ADDENDUM NO. CC-3

TELEGRAPH DISTRICT  
401 BUILDING RENOVATION  
LINCOLN, NEBRASKA  
DLR GROUP PROJECT NO. 10-16202-00

COMBINED CONTRACT

March 21, 2016

UPPER FOUNDATION PLAN  
SCALE: 1/8" = 1'-0"

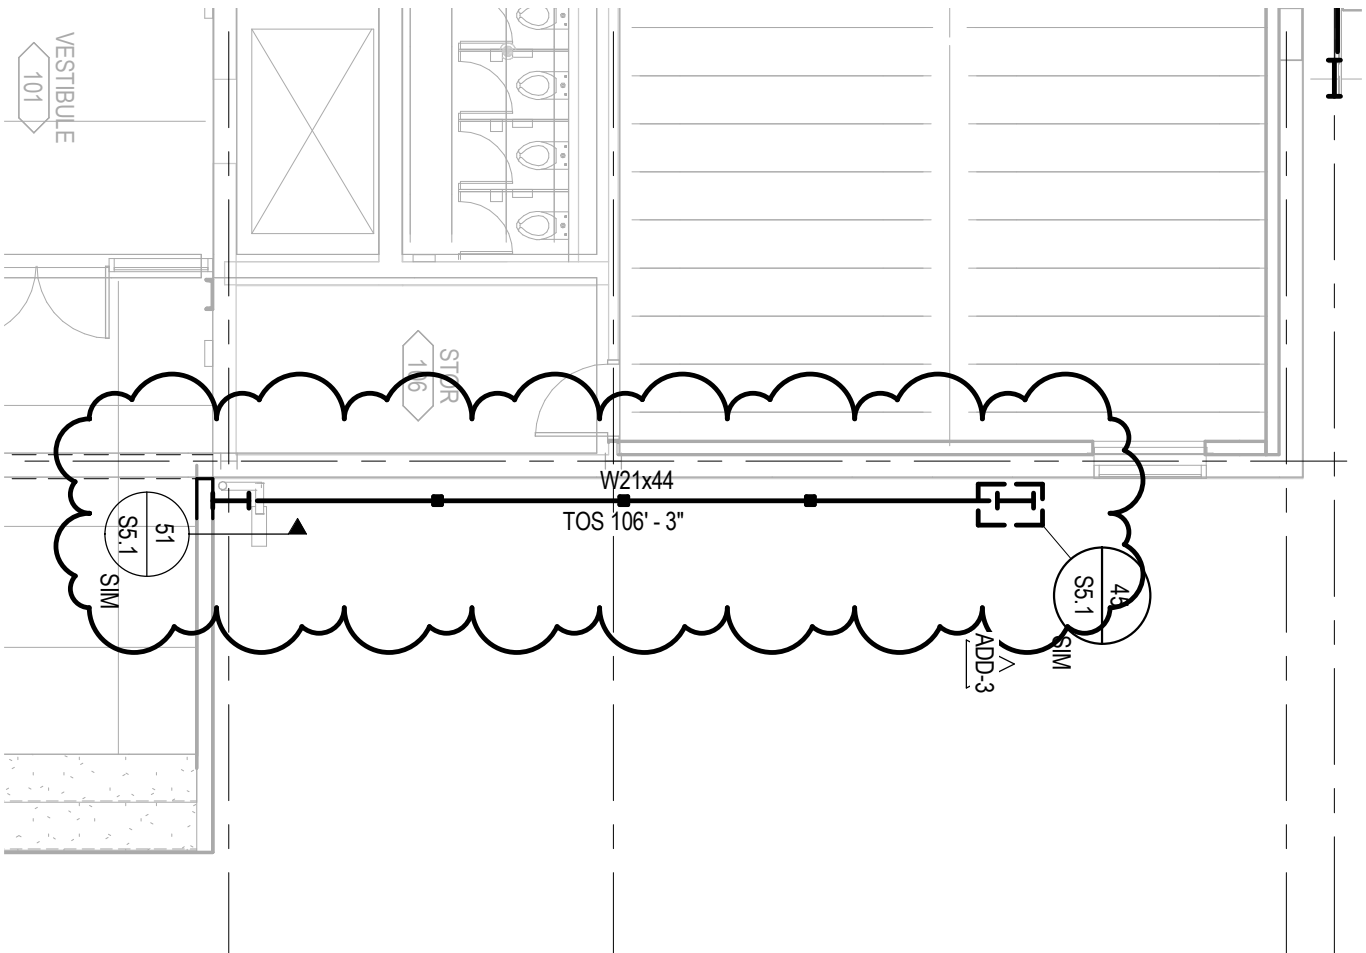
ITEM NO. 1 DRAWING S1.2 UPPER FOUNDATION PLAN

- A. Modify drawings as shown on Attachment S1.2-1

Attachment No. S2.1-1  
to Addendum # 3  
Dated: 03/21/03

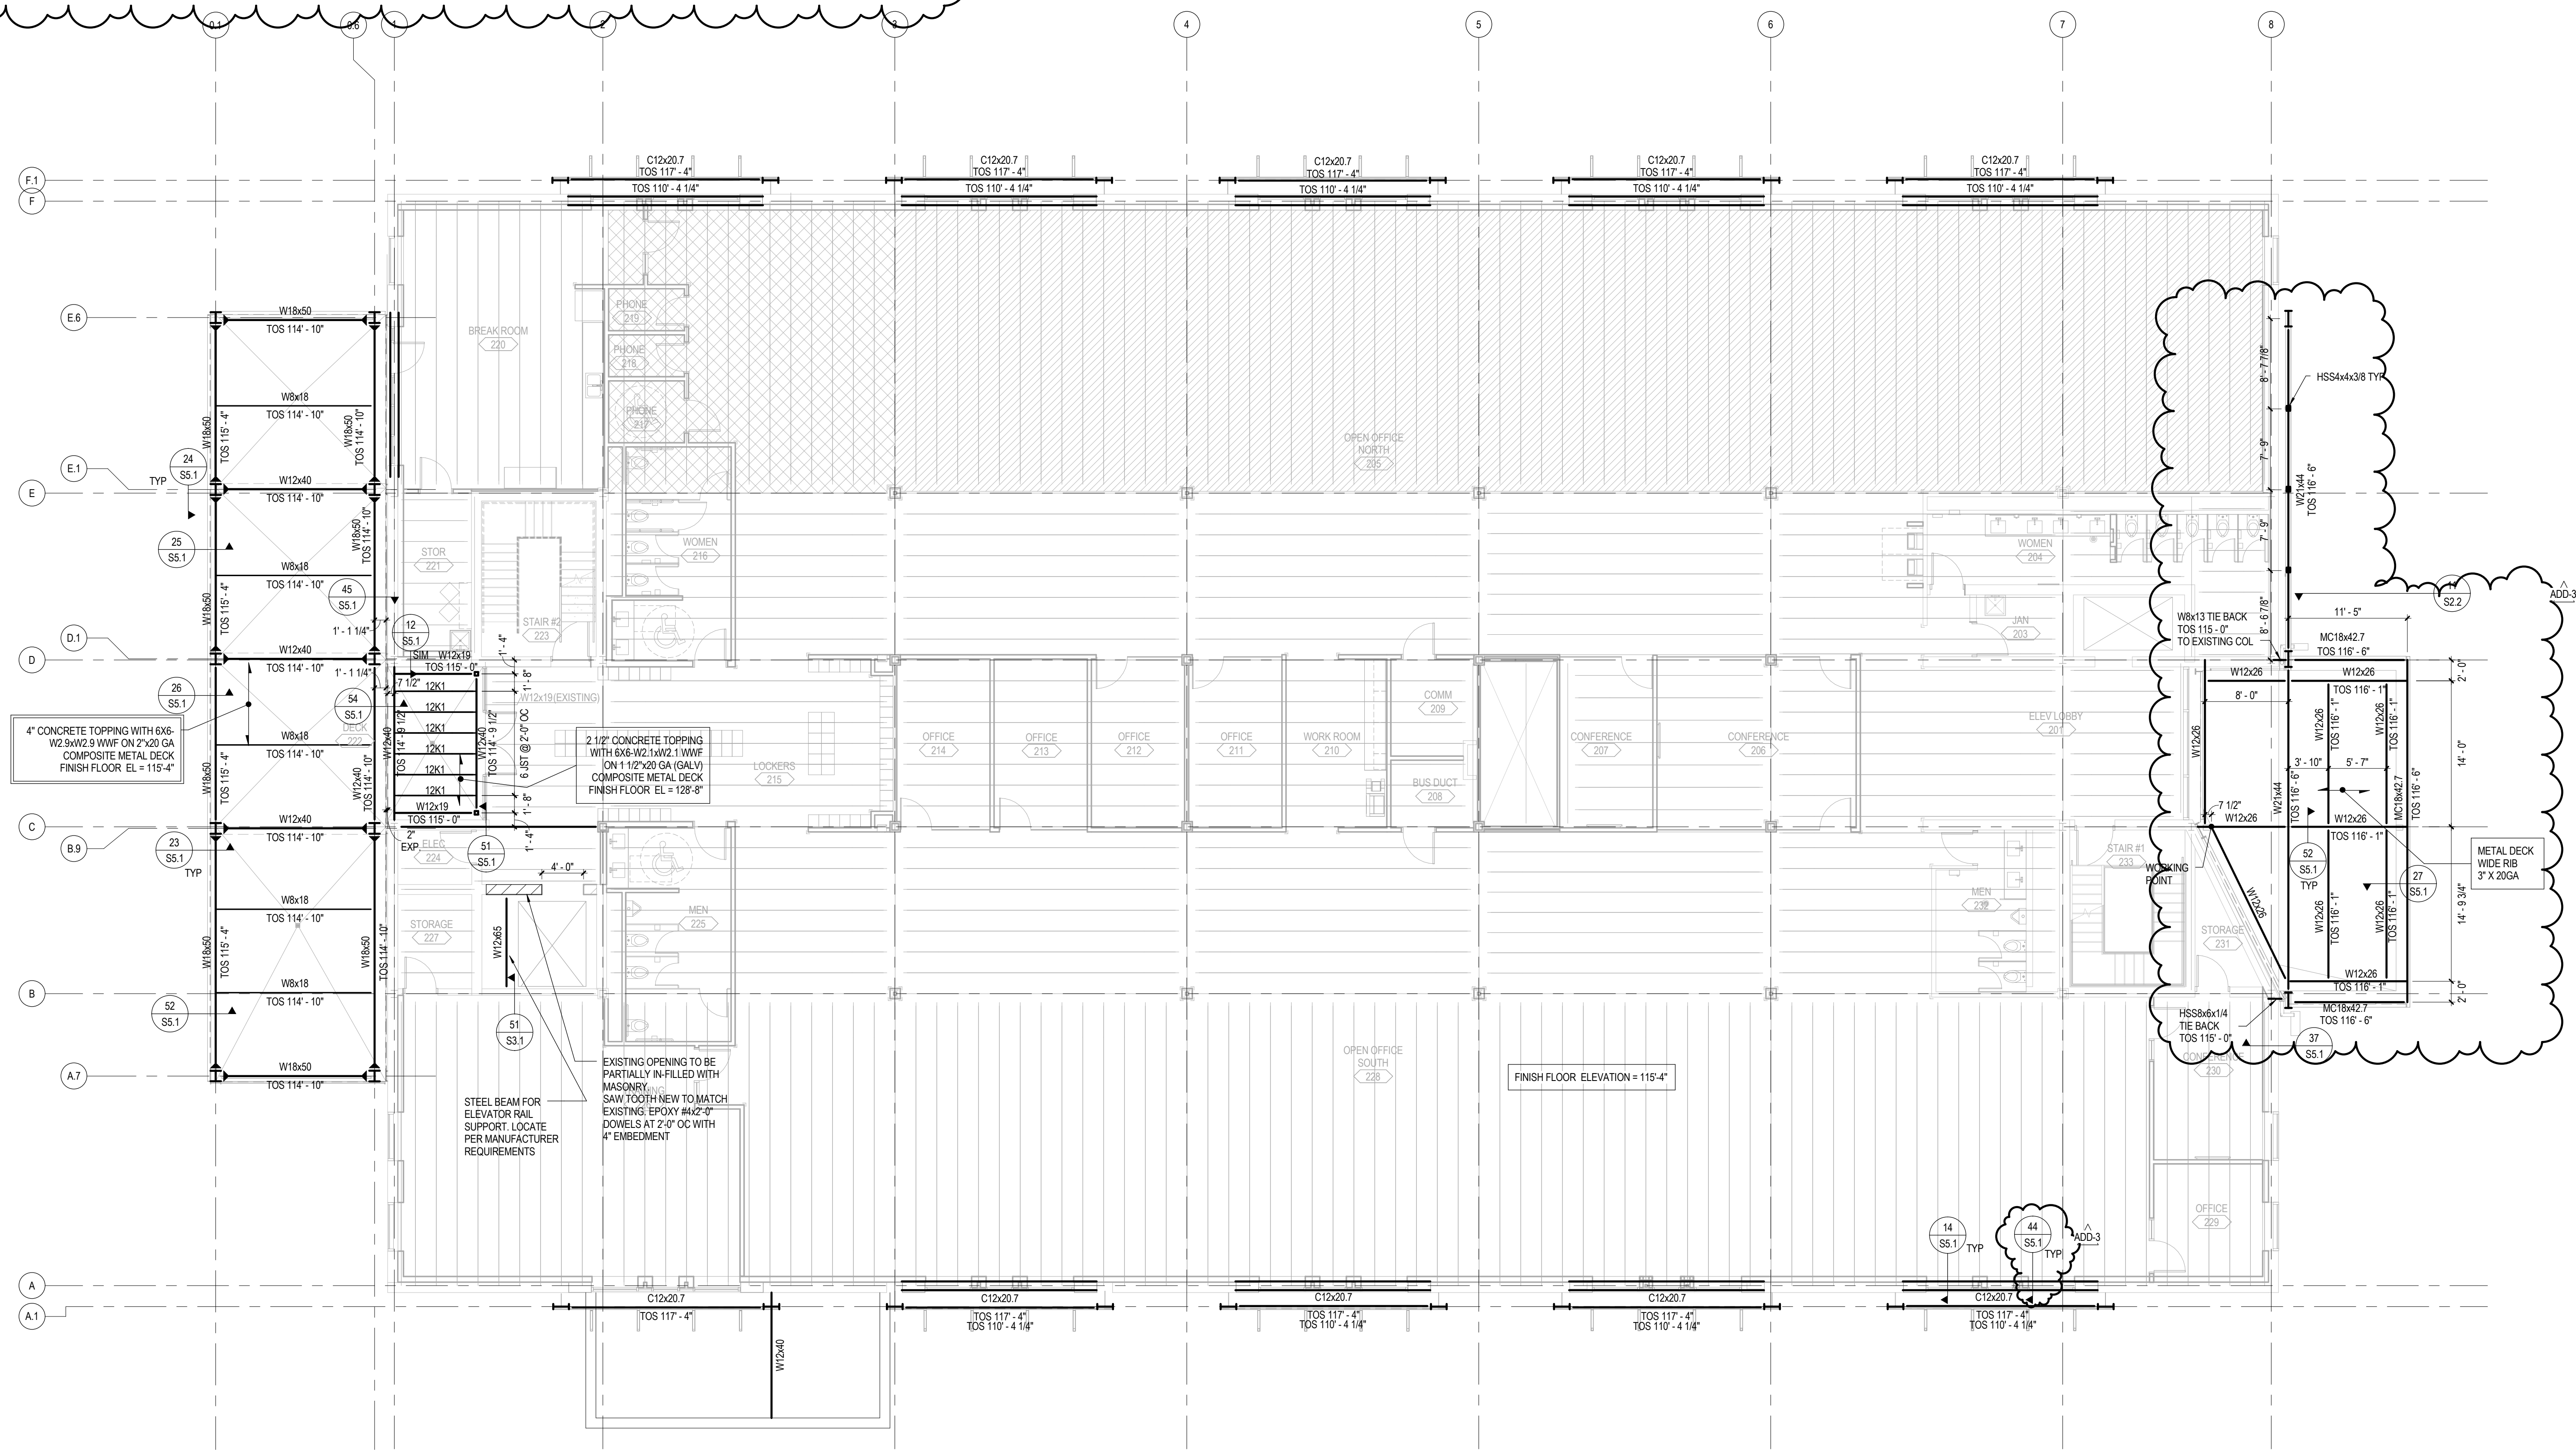
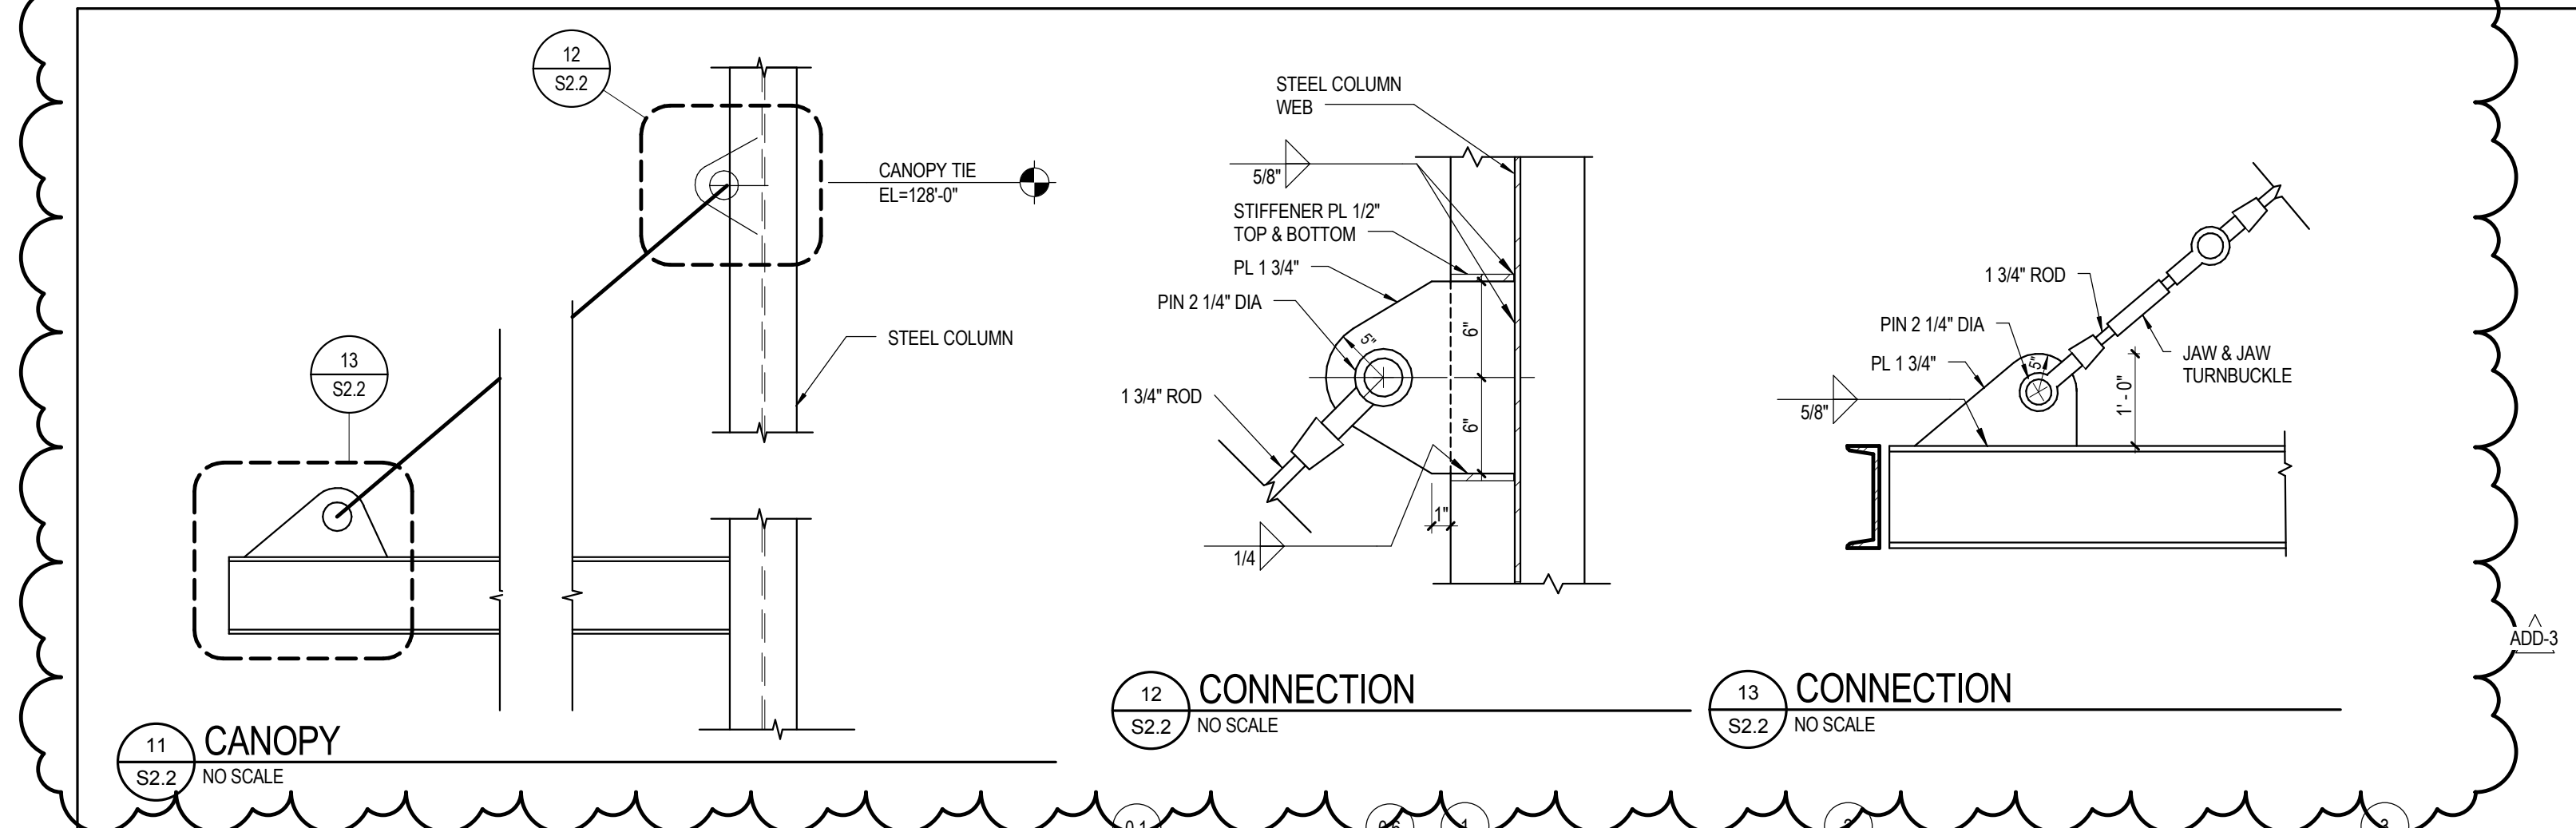
ITEM NO. 2 DRAWING S2.1 FRAMING PLAN – LEVEL 1

- A. Modify drawings as shown on Attachment S2.1-1

**FRAMING PLAN - LEVEL 2**  
SCALE: 1/8" = 1'-0"

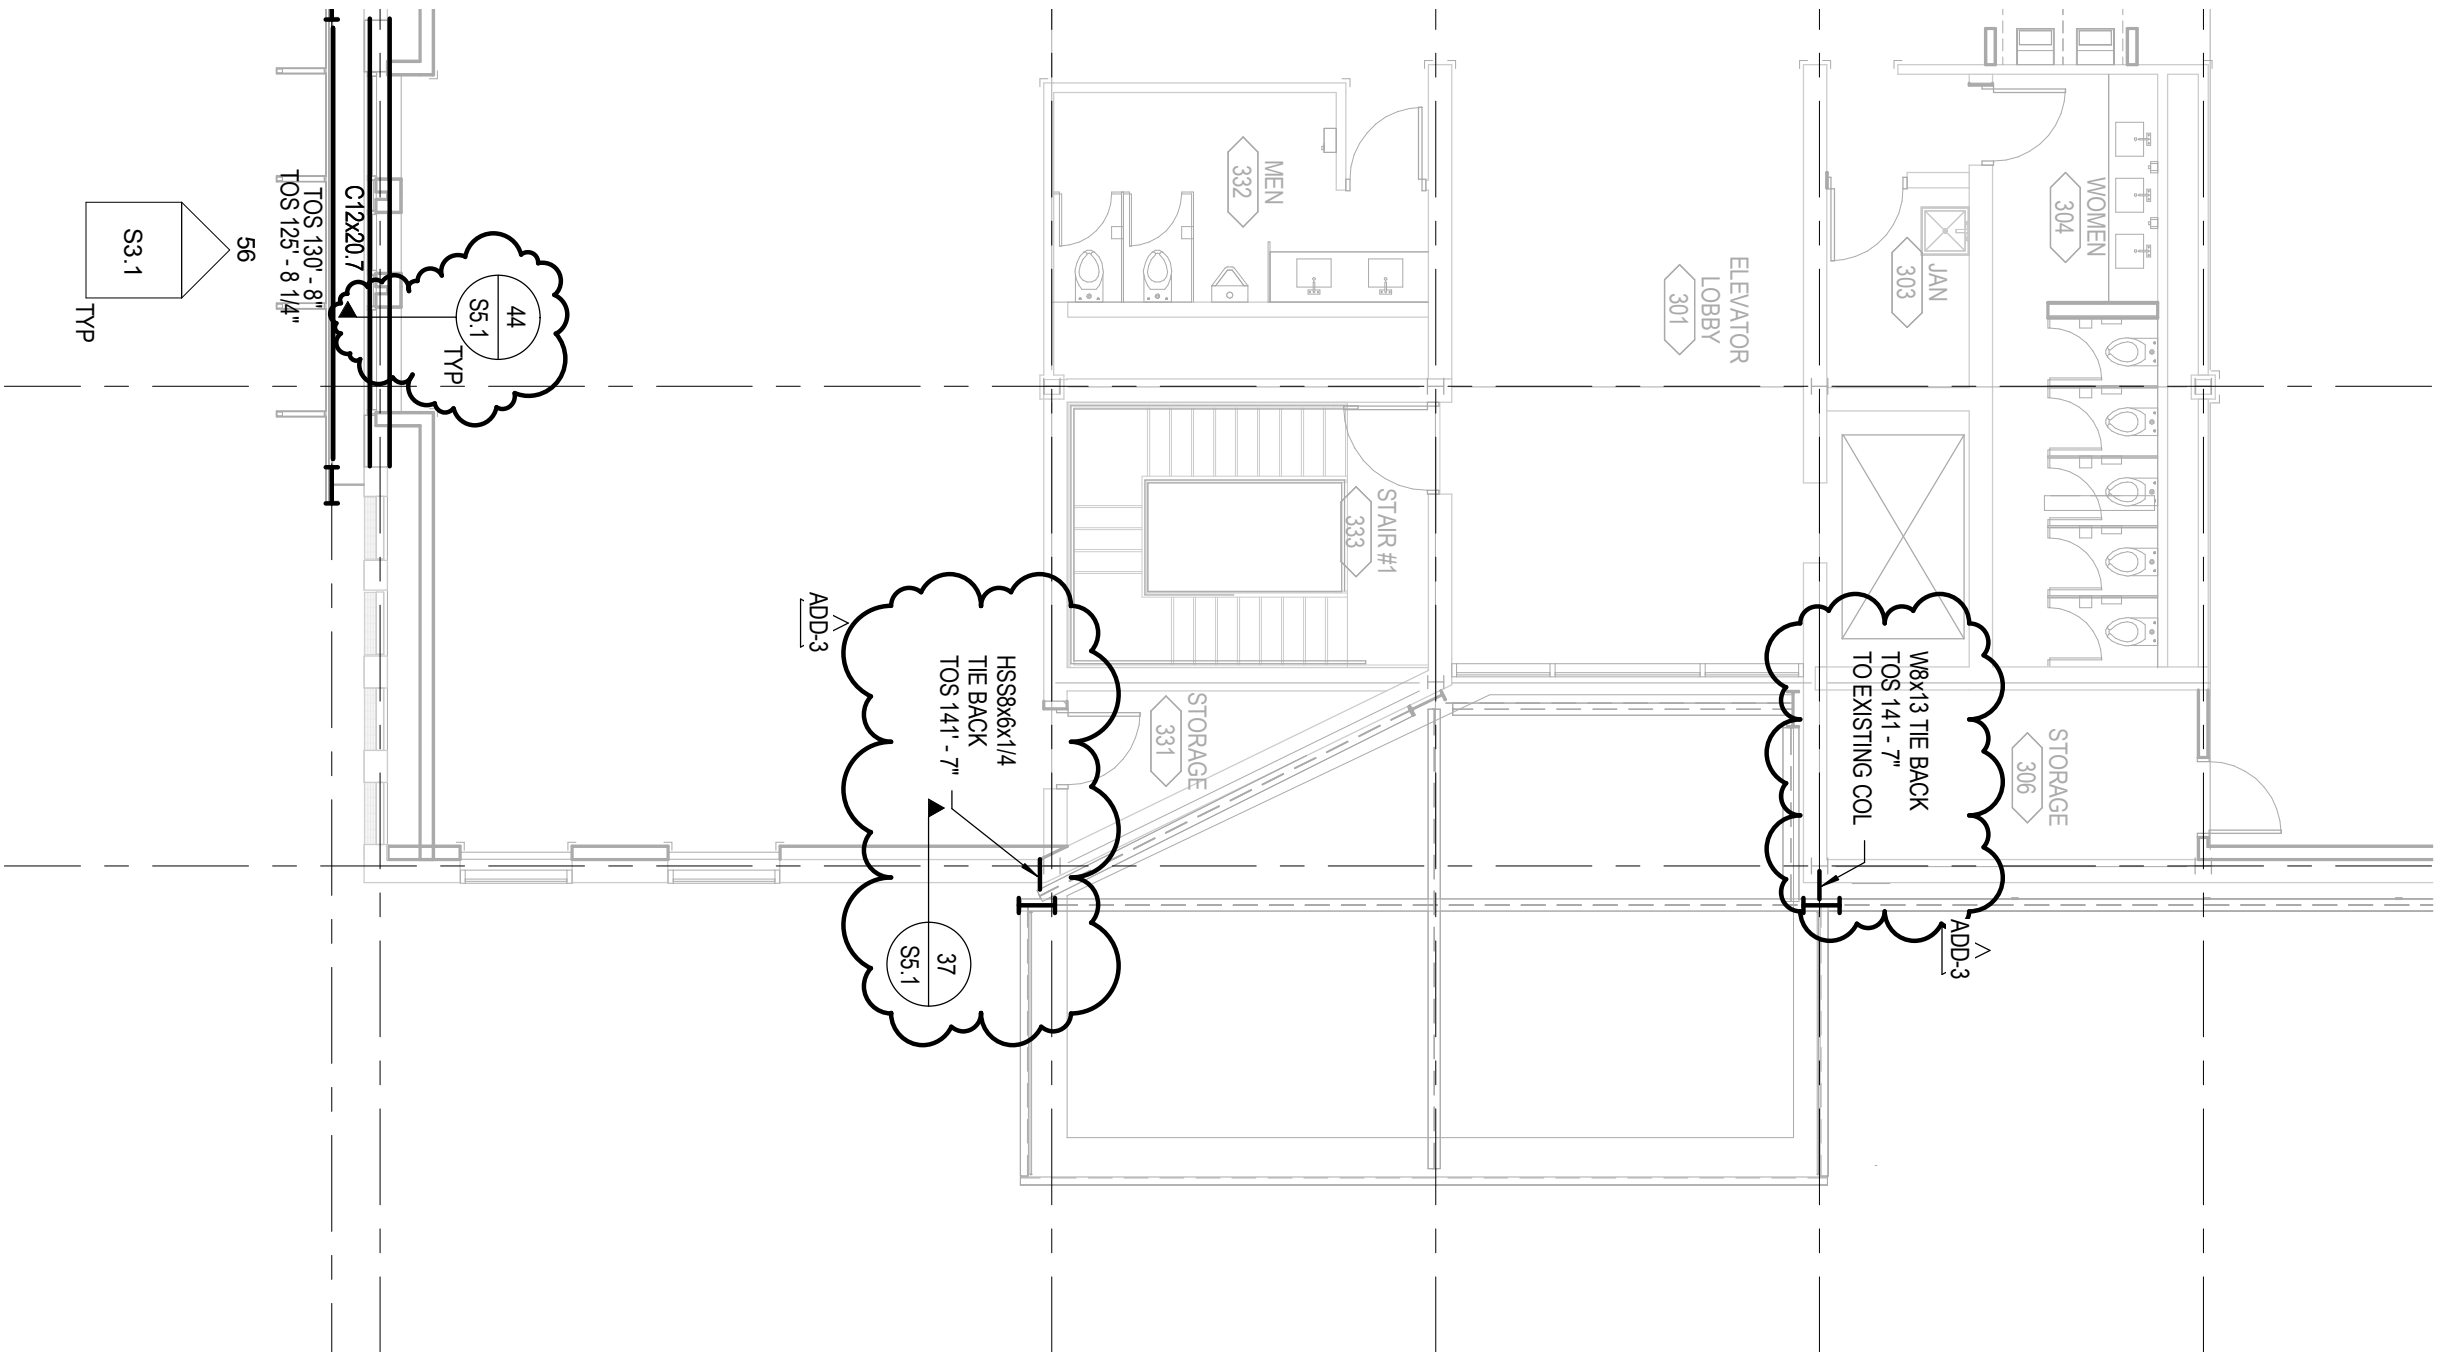
ITEM NO. 3 DRAWING S2.2 FRAMING PLAN – LEVEL 2

- A. Modify drawings as shown on Attachment S2.2-1
